AGENDA

Planning Committee Meeting to be held at
Preston Town Hall,
284 Gower Street Preston
on Monday 12 April 2021 at 6.30pm.

5.1 APPLICATION FOR PLANNING PERMIT D/664/2020 765-769 Gilbert Road Reservoir

**5.2 APPLICATION FOR PLANNING PERMIT D/93/2020
1 UNION STREET PRESTON VIC 3072****Author:** Statutory Planner**Reviewed By:** General Manager City Sustainability and Strategy

Image 3: Distance from secluded private open space to south

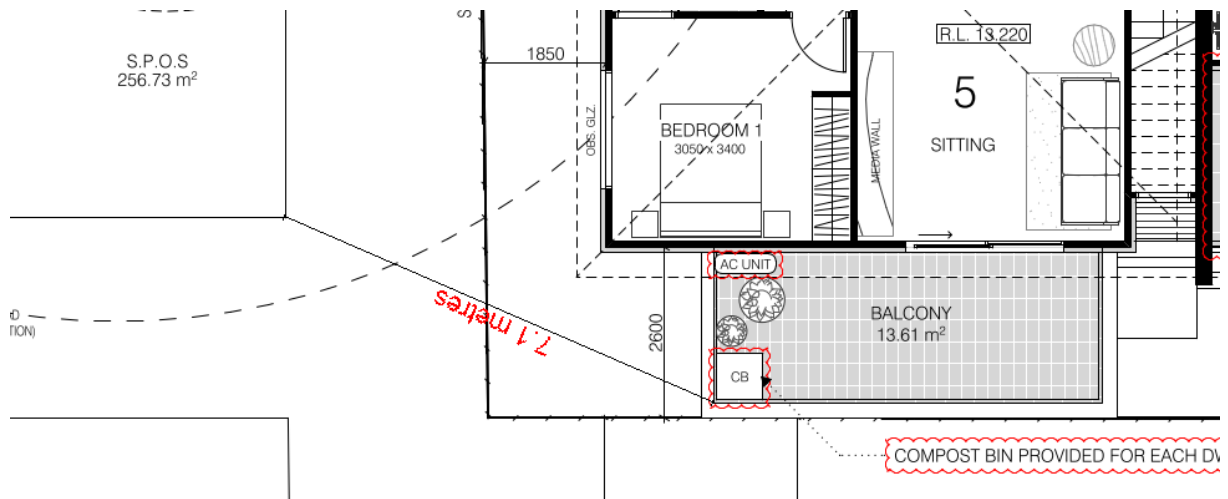
At the first floor, upper storey windows are generally designed and/or screened to ensure no overlooking. However, a permit condition has been added to ensure all obscure glazing associated with south and west facing habitable room windows are confirmed as being not more than 25% transparent and not film, in accordance with standard requirements.

A condition has also been added for the Dwelling 5 balcony to be provided with a fixed screen at the south elevation as this is within 9m of neighbouring secluded private open space. No screening is required for the north and east elevation of this balcony as there are no habitable room windows or balconies within 9m.

Image 5: Distance from new windows to existing windows

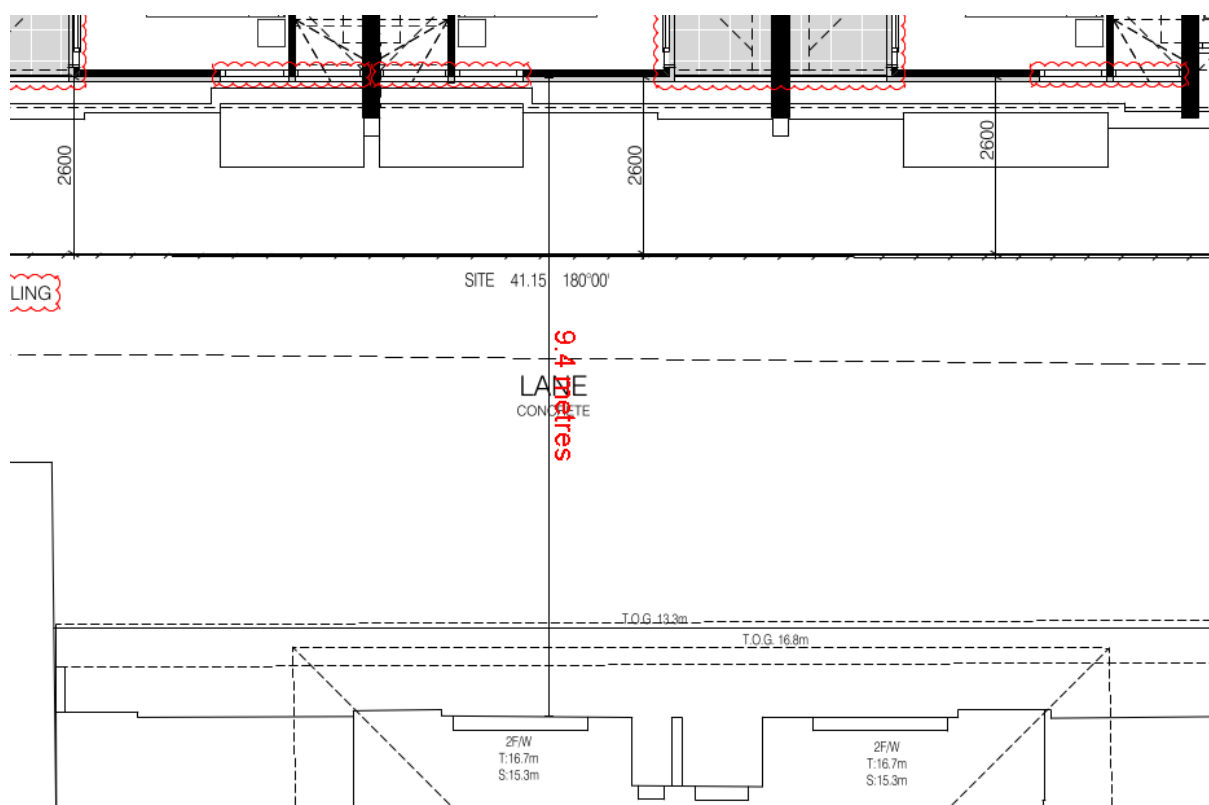
Screening measures do not apply to east elevation windows and terraces for Dwellings 1 – 4 as these are not within 9 metres of neighbouring habitable room windows and balconies.

Complies, subject to condition

Figure 6: West elevation showing the disparity in height and building massing between the proposed development and adjoining lots along 'Little' High Street.

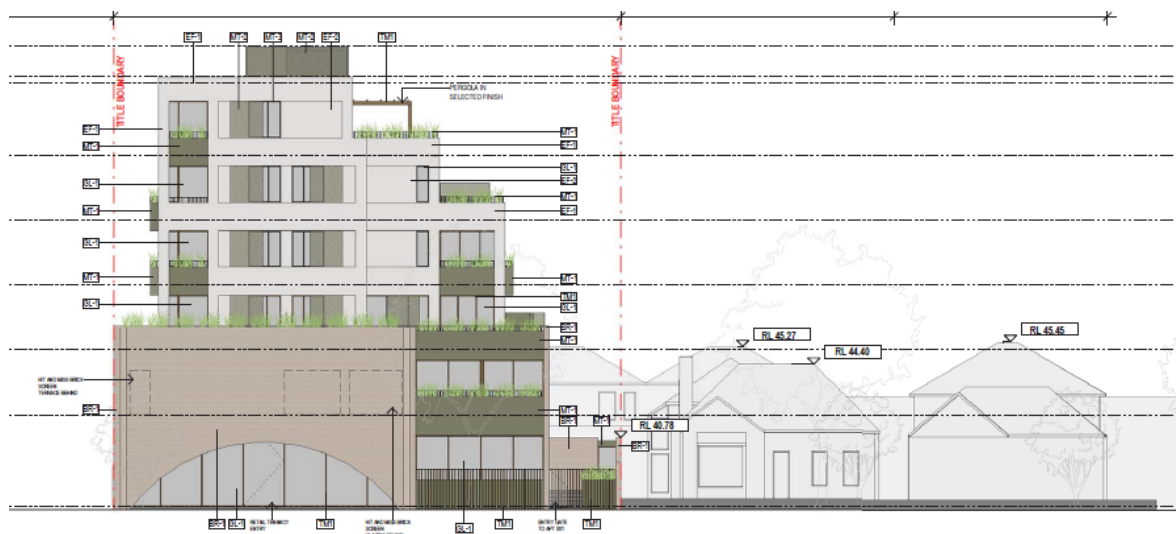
Does not comply

Figure 8: The balcony noted with 'number 2' in the diagram shows a south facing dwelling which has the balcony completely covered by an upper level balcony.

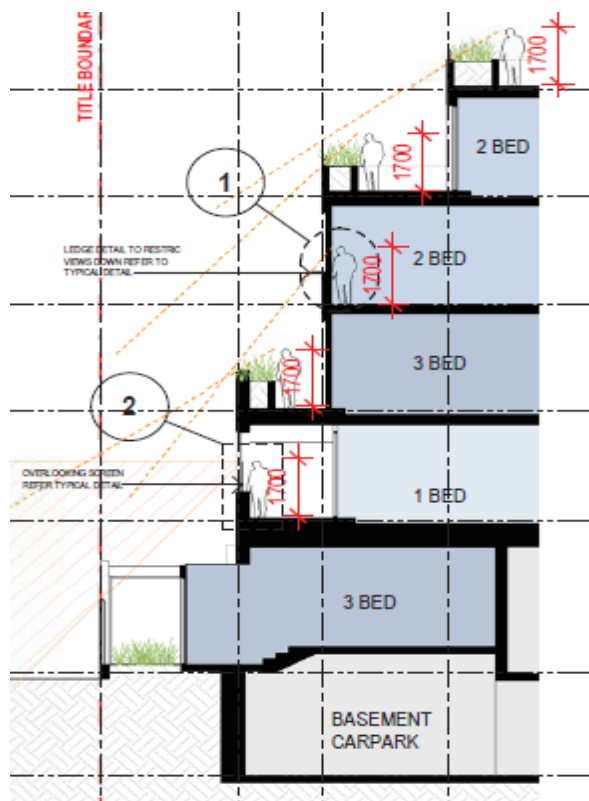
- There are no fixed external sun shading devices to multiple top-level north facing habitable room windows. While it is acknowledged that the proposed development will have a high energy rating, the dwelling on the top floor will be susceptible to excessive heat gain.
- South (side) facing dwellings (on level 1 and level 2) which have an overhang above the balconies (see figure 8 below).

- No detail provided of window type and operation.
- Over-hanging balconies which will reduce sunlight into lower level habitable rooms.

Figure 10: Basement level of the development showing 5 metre long car spaces with storage cages abutting.

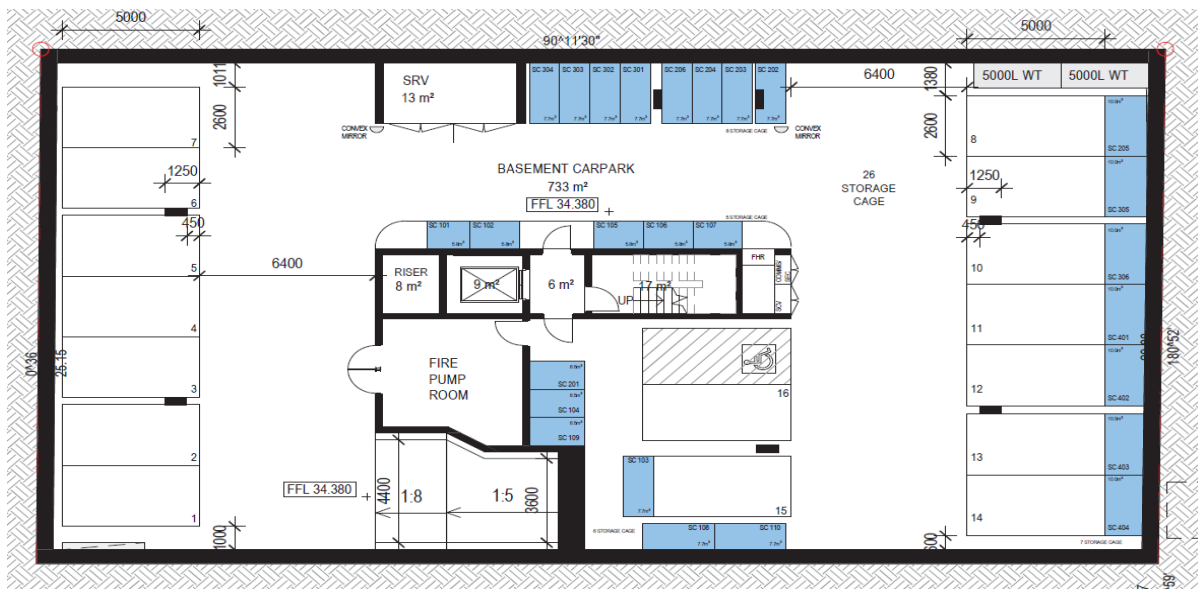
The applicant has indicated that all dwellings have storage space in the form of both internal and external storage cages in compliance with the requirements of this standard, however, it is unclear how the storage cages to the rear of the car stackers will be accessed when the car spaces are occupied. The car spaces measure 5 metres in length, with no space provided between the car stackers and the storage cages (see figure 10 below).

Does not comply

There are 11 car spaces within a two (2) level independent car stacker system. The traffic report which accompanies the application states that the access aisle is 6.4 metres, however, the plans show an aisle width to be 6.1 metres opposite structural piers. Additionally, the traffic report notes that a vehicle length of 5.2 metres can be accommodated by the stackers, however, there are storage cages at the end of these spaces which reduces the car lengths to 5 metres (see figure 10 above).
